Re: *Standards of Performance for New, Reconstructed, and Modified Sources and Emissions Guidelines for Existing Sources: Oil and Natural Gas Sector Climate Review (RIN 2060-AV16)*
Docket ID No. EPA-HQ-OAR-2021-0317

**AXPC Specific Comments on
EPA’s Supplemental Notice of Proposed Rulemaking:
Proposed Standards of Performance for New, Reconstructed, and Modified
Sources and Emissions Guidelines for Existing Sources: Oil and Natural Gas
Sector Climate Review
Docket ID No. EPA-HQ-OAR-2021-0317**

Cimarron Energy Inc., Model: ECD-3-48HV-90 Design Capacity Flow Curve

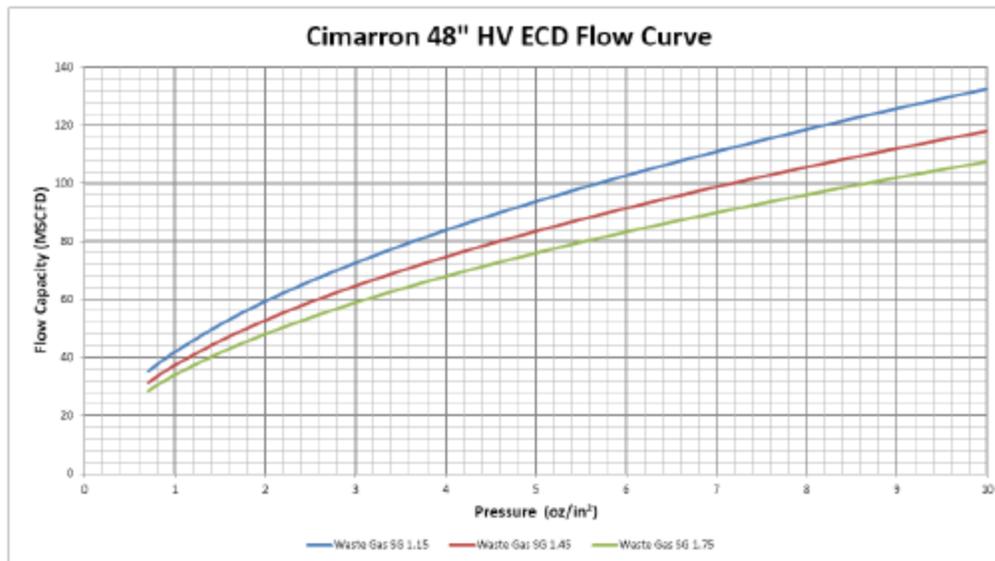
*AXPC provides this design capacity flow curve for the purpose of demonstrating that combustion control device manufacturers rate a control device's design capacity relative to pressure. In providing this document, AXPC's intent is not to provide an endorsement or recommendation of the use of this control device or other control devices sold by the manufacturer.
